BEFORE THE PUBLIC SERVICE COMMISSION
OF THE STATE OF MISSOURI

In the Matter of Evergy Metro, Inc. d/b/a	)	
Evergy Missouri Metro's 2025 Integrated	)	Case No. EO-2025-0250
Resource Plan Annual Update Filing	)

In the Matter of Evergy Missouri West, Inc.	)	
d/b/a Evergy Missouri West's 2025 Integrated	)	Case No. EO-2025-0251
Resource Plan Annual Update Filing	)

**SIERRA CLUB'S COMMENTS ON EVERGY'S 2025
INTEGRATED RESOURCE PLAN UPDATE**

Figure 1: Jeffrey Unit 1 Gross Hourly 2024 Generation (MW) and SPP Daily Peak Load (MW)⁵

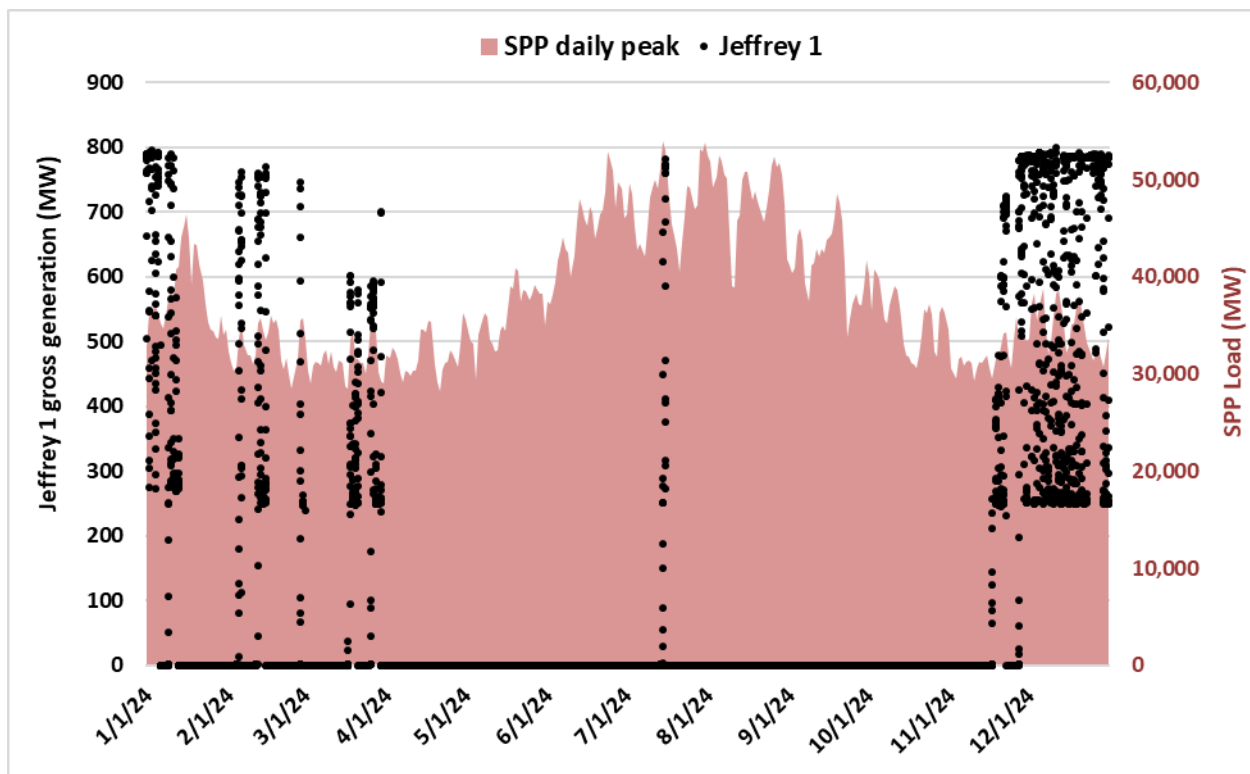
Like other utilities, Evergy defends its decisions by citing to reliability. But coal units are inflexible and can be unreliable. As a case in point, Figure 1 depicts the hourly gross load for Jeffrey unit 1 in 2024 along with the SPP daily load. As shown below, the unit did not operate for the majority of the year—it operated only during 19 percent of hours in 2024.⁴ Most importantly,

the unit was out for SPP’s winter peak in January and for almost all of the summer peak hours in July and August.

- **Deficiency 1:** The IRP fails to consider the early retirement of Jeffrey 1 despite the unit's abysmal performance, most notably its lack of reliability. The IRP needs to consider plans that retire the unit as soon as feasible.
- **Deficiency 2:** The IRP should evaluate earlier retirement and gas conversion for other units that have been mostly uneconomic on the SPP energy market and/or unreliable.

Figure 2: Jeffrey Unit 1 Hourly Winter 2024 Gross Generation (MW) and SPP Daily Peak Load (MW)⁹

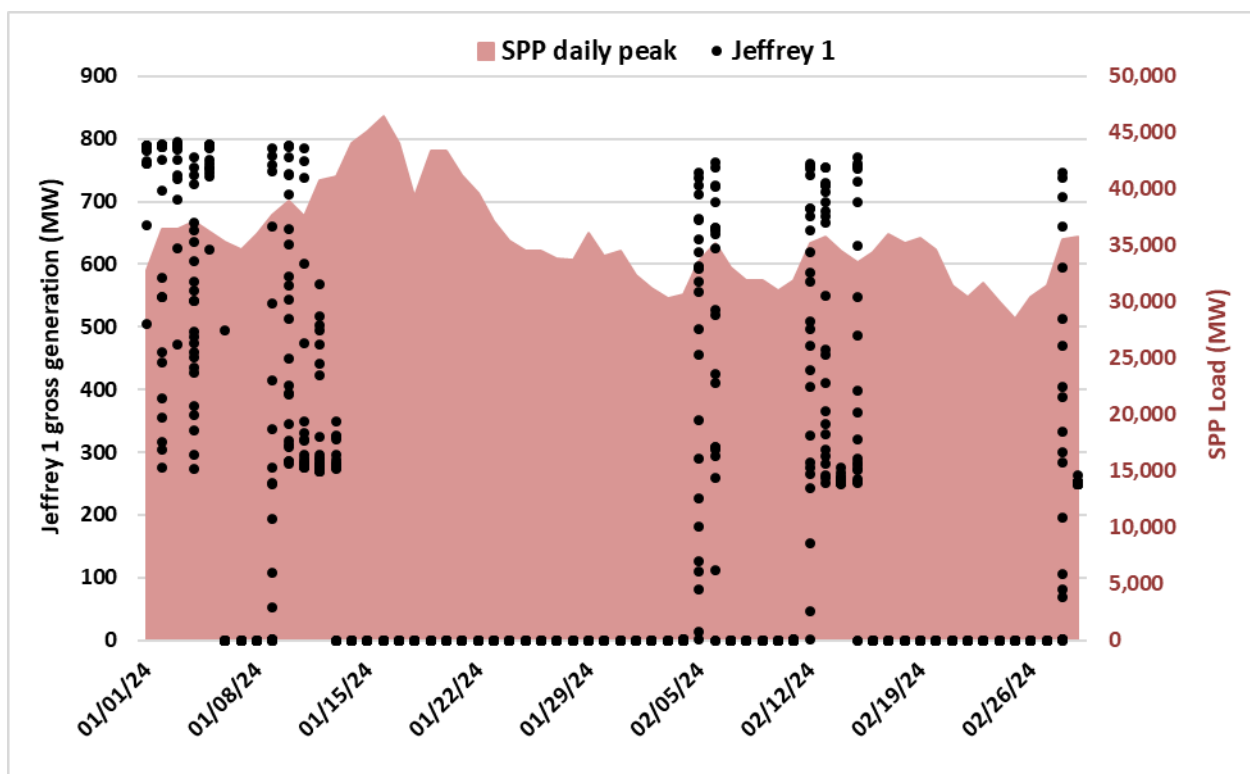
The Company has addressed winter reliability in this update by increasing winter reserve margins. At the same time, however, one of the units that Evergy has failed to even test for early retirement, Jeffrey unit 1, was unreliable when needed last winter. The unit was unavailable during the SPP winter peak last year in mid-January 2024 during most of Winter Storm Gerri—as shown below in Figure 2. Sierra Club’s previous comments on the 2024 IRP noted that the unit was on a forced outage for 67 percent of the hours in January 2024 and 31 percent of hours

in February.⁶ The unit was also out during Winter Storm Uri in 2021.⁷ (It ran during Winter Storm Elliott in 2022 but unit 3 did not.⁸) The Company should not use reliability as an excuse for failing to even consider retirement of this unit in the next 14 years.

Figure 6: Evergy Metro Limit on Market Access²³

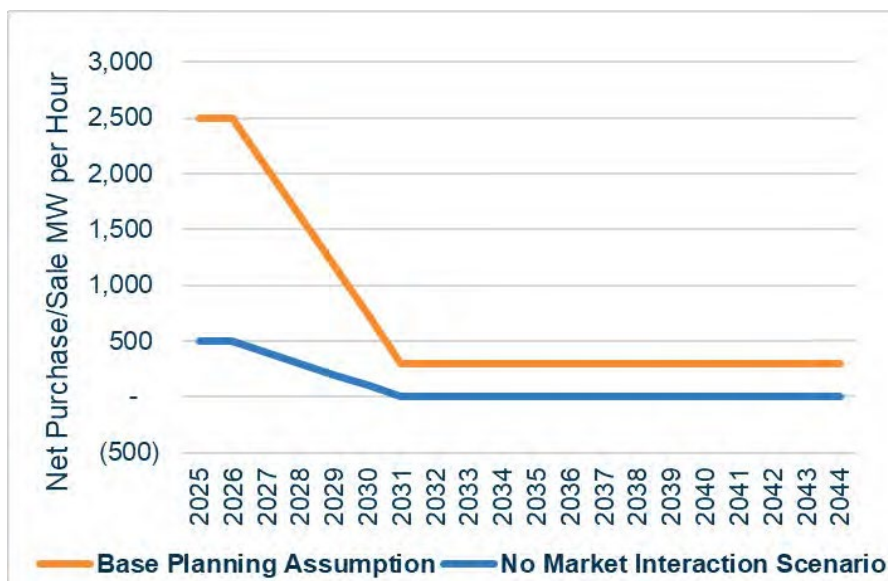
In this IRP update, Evergy is limiting market access by capping net purchases and sales to roughly 10 percent of peak load or 15 percent of average load at each hour.²² This constraint on the model is too restrictive because of Evergy's participation in the SPP energy market, whereby the Company's customers receive all of their energy from SPP and the Company's generators simultaneously sell all of their energy into SPP. In addition, the constraint does not appear to increase with the load forecast, so the *percentage* of peak or average load is actually decreasing over time because load is expected to increase but the megawatt cap on market purchases and sales stays the same—as shown in Figure 6 below. Moreover, the Company also ran a scenario

with no market interaction, which was a response to stakeholder feedback. Such a scenario should be ignored because it is treating the Evergy system as an isolated, electrical island which exacerbates the flaws of placing a strict cap on purchases and sales.

Placing strict limitations or completely cutting off the movement of electricity in and out of Evergy’s system belies the reality that its system is inextricably intertwined with the SPP grid. Imposing constraints on an hourly basis is particularly problematic because there could be hours where either Evergy needs more from the grid or can produce substantial power to sell to the grid. Thus, instead Evergy could limit *annual* purchases and/or sales if it was concerned about overbuilding generation to serve the market or overreliance on the market. Such a limitation would still allow for high levels of purchases and sales in certain hours where it makes economic sense.

- **Deficiency 5:** The IRP should relax energy market access constraints and allow for more than 10 or 15 percent of all annual energy to be purchased and sold. The Company also should ignore any scenario with no market access, as such a scenario ignores reality and the benefits of membership in a regional grid.
- **Deficiency 6:** The IRP should address the congestion in western Kansas and evaluate how it affects the economics of its plans, most notably the new gas resources.

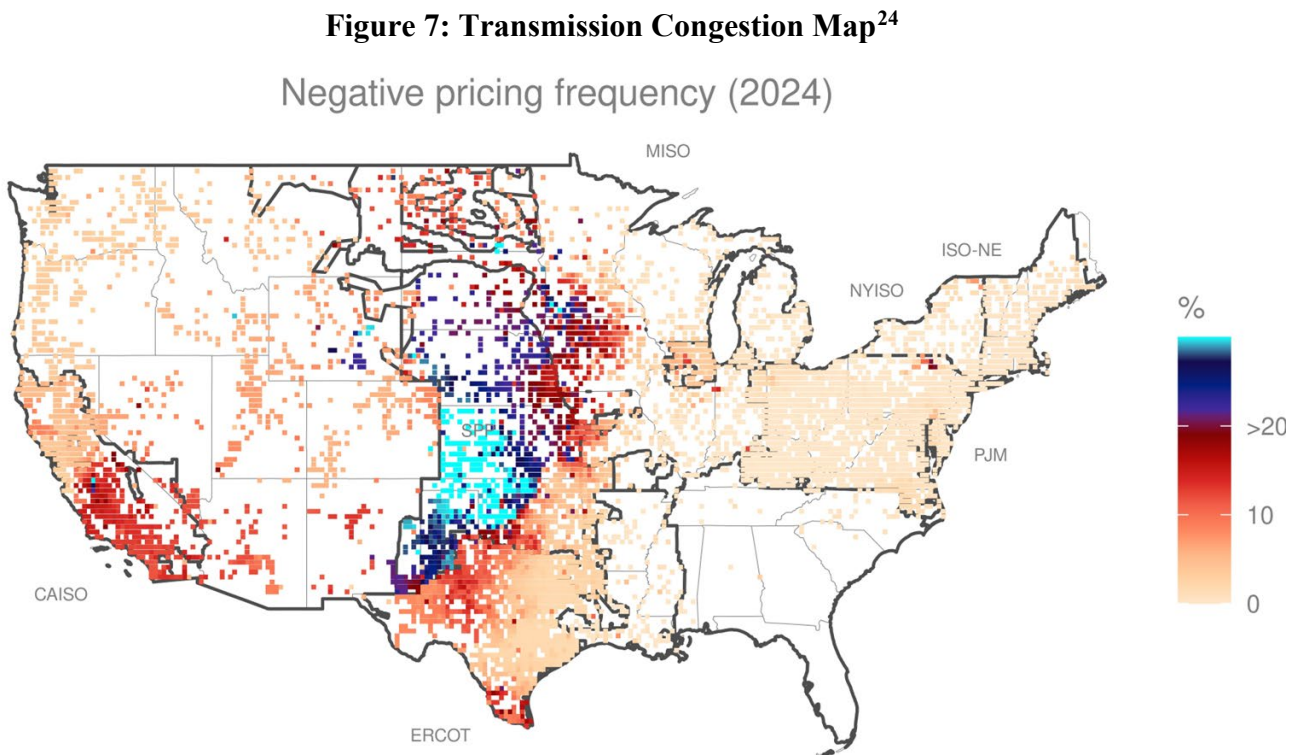
Evergy should also address the congestion in its western service territory. This area is often oversupplied with generation that cannot reach the eastern part of its territory because of

transmission limitations. Figure 7 below shows the share of hours with negative energy prices throughout the U.S.—central and western Kansas and Oklahoma have the highest concentration of these hours.

Sierra Club recently filed testimony by witness Michael Goggin before the Missouri Commission which highlighted the risks of Evergy locating new gas resources in such areas where there are low or often negative energy prices.²⁵ Mr. Goggin found that when Evergy assessed the economics of three proposed gas plant additions (Viola, McNew, and Mullin Creek Unit 1), it failed to account for this congestion, therefore ignoring a major economic risk that the
